SERVICE INFORMATION NO. SI 20-065

EASA EAD 2013-0117-E
Rotax Alert Service Bulletin ASB-912-062R2

ALERT SERVICE BULLETIN

Checking of the cylinder head assy. (2/3) for ROTAX® Engine Type 912 and 914 (Series)

Bild 1
Zündkerzen

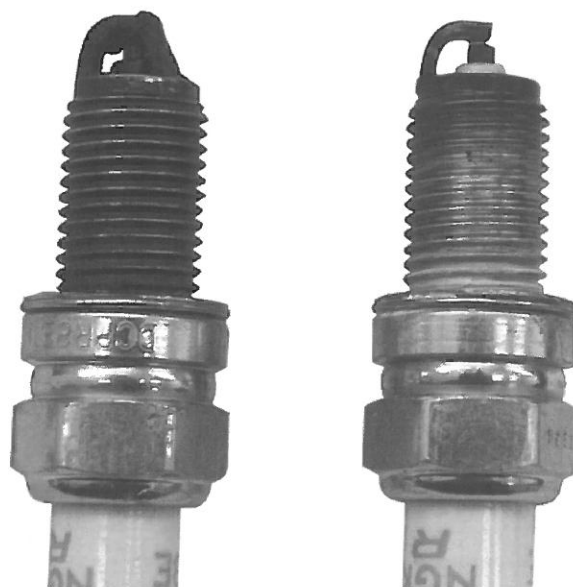
3.1.2) Kontrolle des Zündkerzenbildes am Zylinder 2 und Zylinder 3

Siehe dazu Bild 1.

Schritt	Vorgehen
1	Sichtkontrolle an beiden Zündkerzen pro Zylinderkopf (oben und unten) durchführen.

HINWEIS: Übermäßige Ablagerungen (Öl oder Kohle) an der Zündkerze sind ein Indikator für einen defekten Zylinderkopf, welcher getauscht werden muss. Das Bild 1 zeigt den Vergleich zwischen einer bereits gelaufenen aber als in Ordnung befundenen und einer als bereits gelaufenen aber nicht in Ordnung befundenen Zündkerze.

Betroffene Zündkerzen mit derartigen Ablagerungen wie im Anhang Bild 1 dargestellt, sind zu entfernen und dürfen nicht wieder eingebaut werden.
